BHARAT HEAVY ELECTRICALS LIMITED
PROJECT ENGINEERING MANAGEMENT, NOIDA

CORRIGENDUM- 01

PROJECT	:	5 x 800 MW Yadadri TPP
PACKAGE	:	FUEL OIL HANDLING AND STORAGE SYSTEM
ENQUIRY NO	:	PE/PG/YAD/E-5946/2018 Dt. 18.05.2018

Pre-bid Clarification				
Sub: Tender for Fuel Oil Handling and Storage System for 5X800MW YADADRI TPS project (Enq No PE/PG/YAD/E-5946/2018)				
Sl. No.	Section/ Clause/ Page No.	Statement Of the referred clause	Clarification required	BHEL REPLY
1	Section IA/ Clause Annexure-E/ Page No. 203 & Section IA/ Clause 1.1.0(12)/ Page No.12	Pressure Reducing & Desuperheater skid	P&ID no. PE-DG-417-166-A001 Rev.0 Sh. 3 of 3 shows Pressure Reducing & Desuperheater skids as dotted. We presume that being a skid the same is shown as dotted, however it is to be considered in bidder scope. Please confirm that our understanding is correct.	Bidder understanding is correct. The same is in bidder scope.
2	Section IA/ Clause Annexure-E/ Page No. 203 & Section IA/ Clause 1.1.0(12)/ Page No.12	Terminal Point of Instrument Air is not given	P&ID no. PE-DG-417-166-A001 Rev.0 Sh. 3 of 3 shows B/L for Instrument Air Supply for pneumatic control valves. The size & terminal point for Instrumen

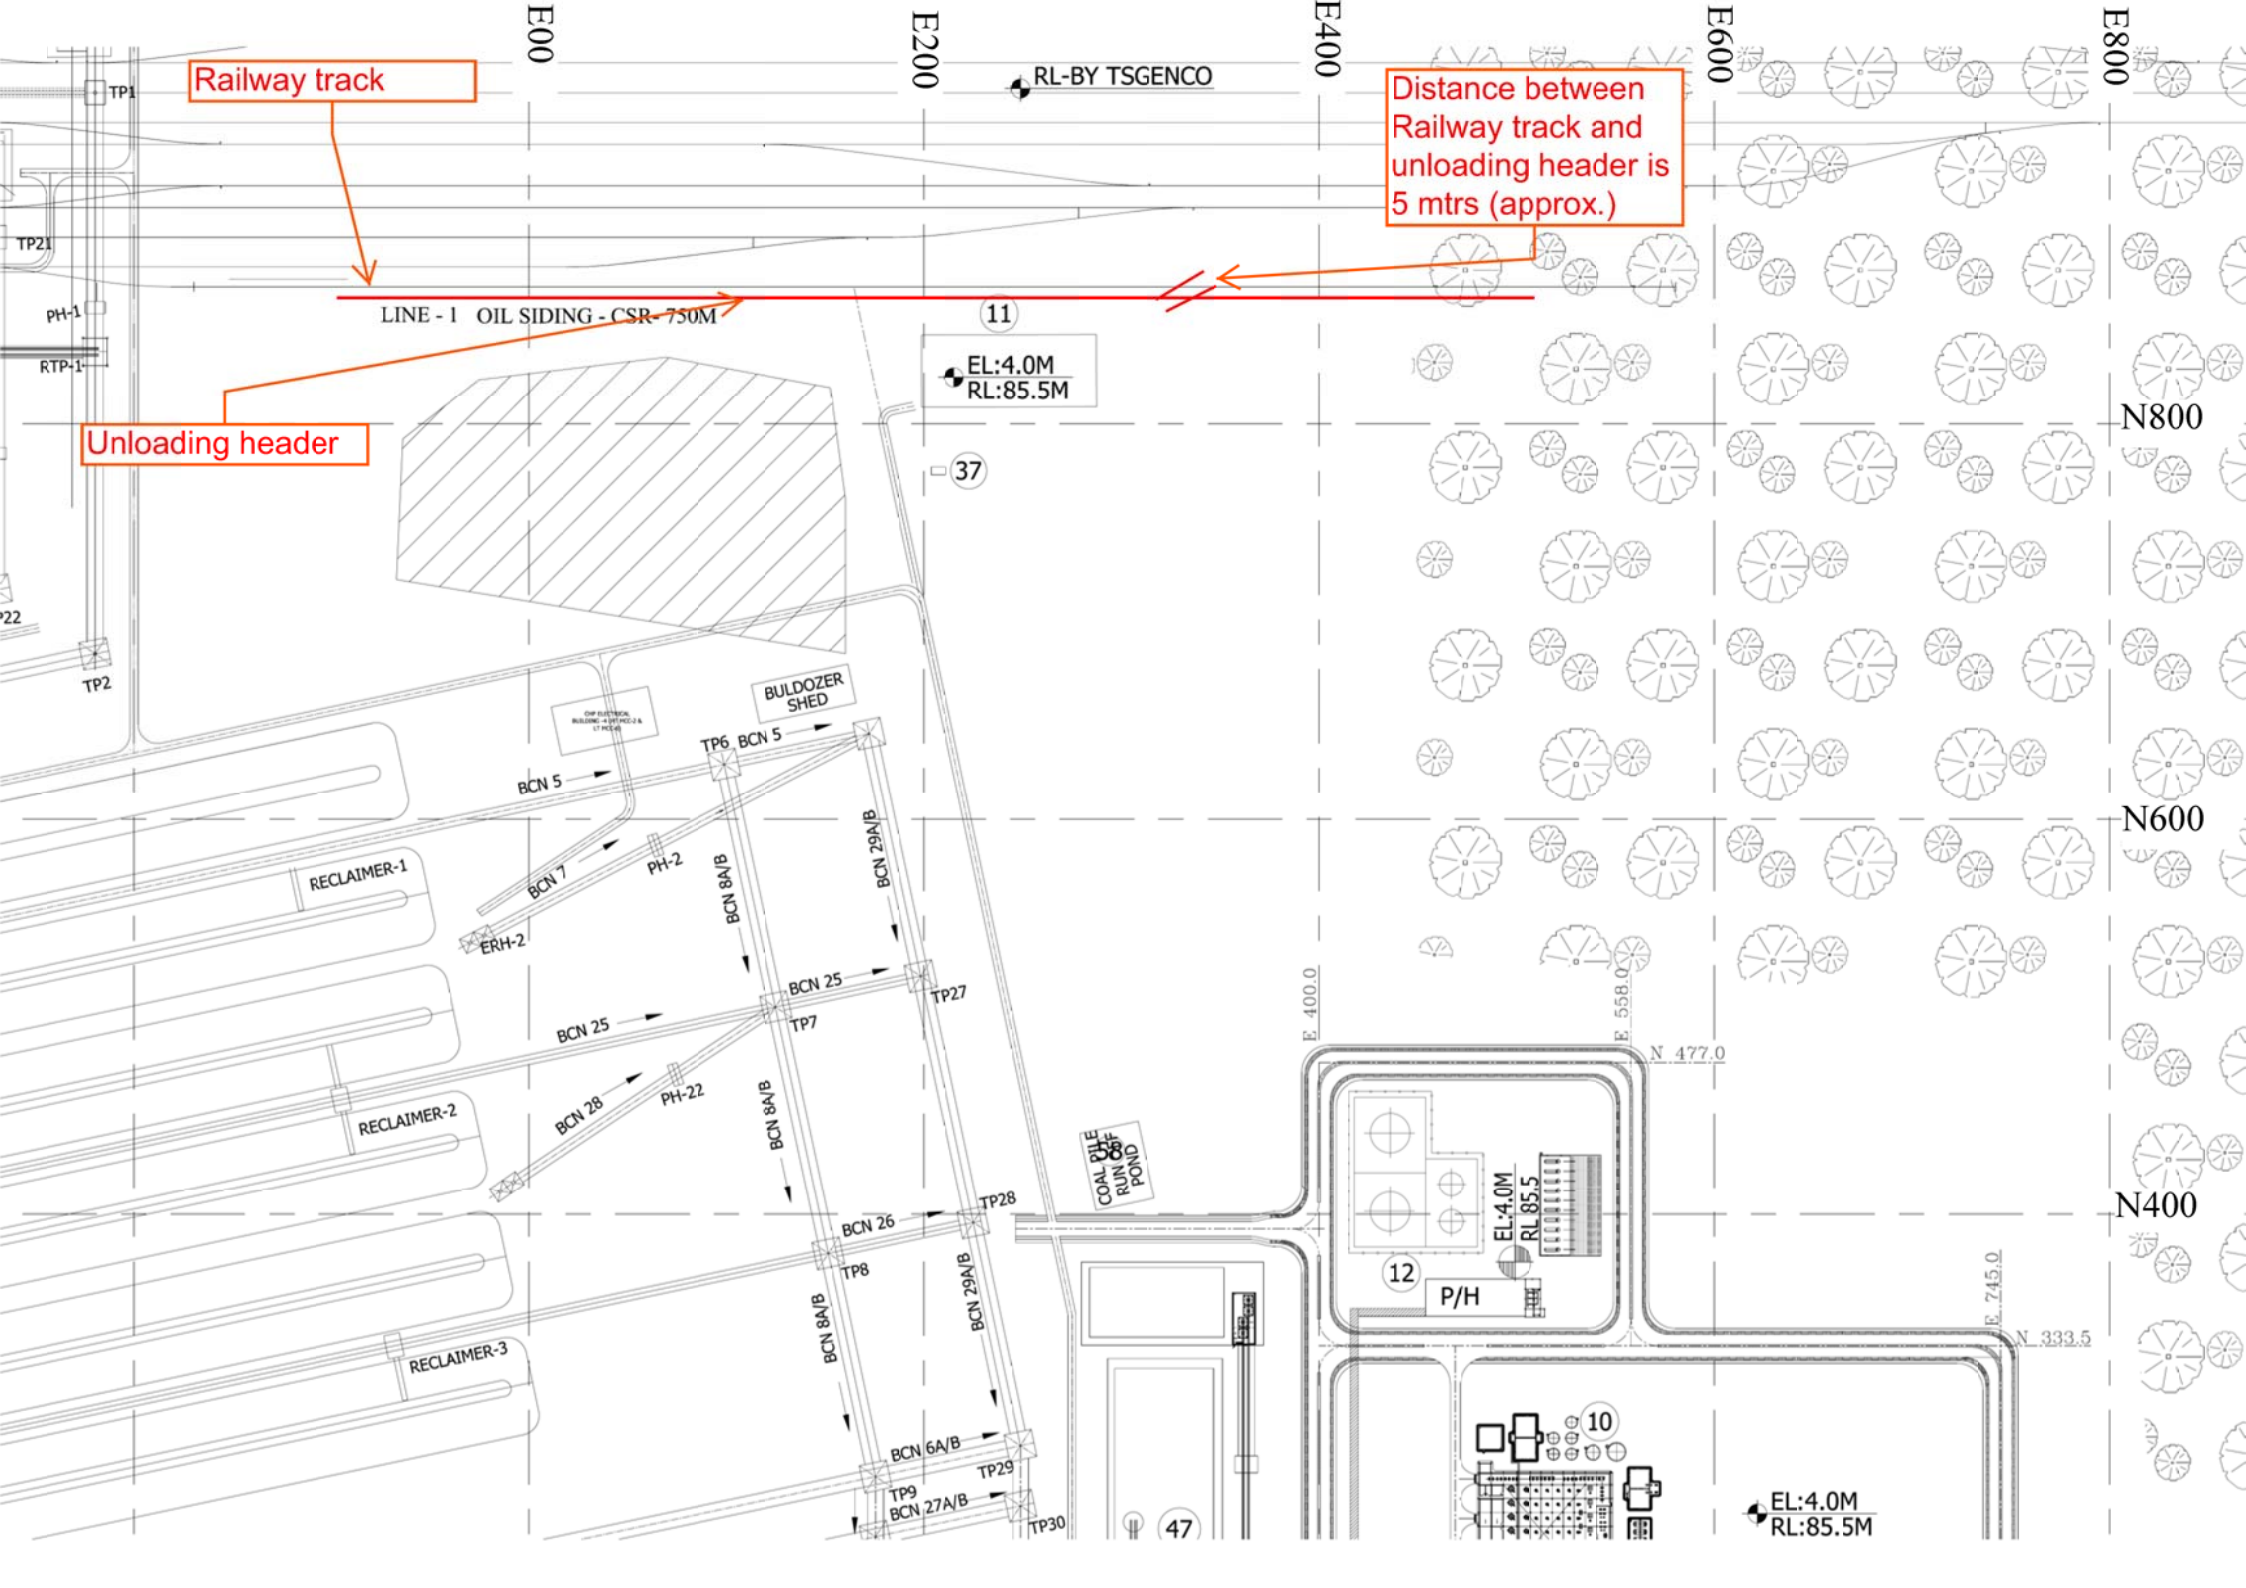
Customer specification, Section - IIIB, Short description of the System, clause no. 3.04.00, Page 34 of 403	Both HFO & LDO/ HSD shall be pumped from the storage tanks to day tanks by transfer pumps . HFO & LDO/ HSD transfer pumps along with strainers etc. will be located in the Fuel Oil Transfer Pump House adjacent to HFO and LDO/ HSD dyke area.		
4	Drawing no. PE-DG-417-166-A001, Rev 0; Process & instrumentation diagram for HFO system	water pit - pump and pipe under ETP scope	From the referred clause we understood that pumps, pipes, instruments and valves coming in water pit is in the ETP scope of supply. Please confirm.	Follow the specification.
	SECTION-IA, System description, Page 26 of 403	Separated water from the oil water separator water pit shall be taken to CMB as per ETP philosophy. Pumps, instruments required for it are in ETP supplier scope.		
5	Drawing no. PE-DG-417-100-M001, Rev 01; Plot plan	HFO unloading area	Kindly mark the coordinates in the plot plan regarding the HFO rail wagons as it is not clear to estimate the HFO unloading and pumping area.	Marked in Plot plan(attached)

Distance between
Railway track and
unloading header is
5 mtrs (approx.)
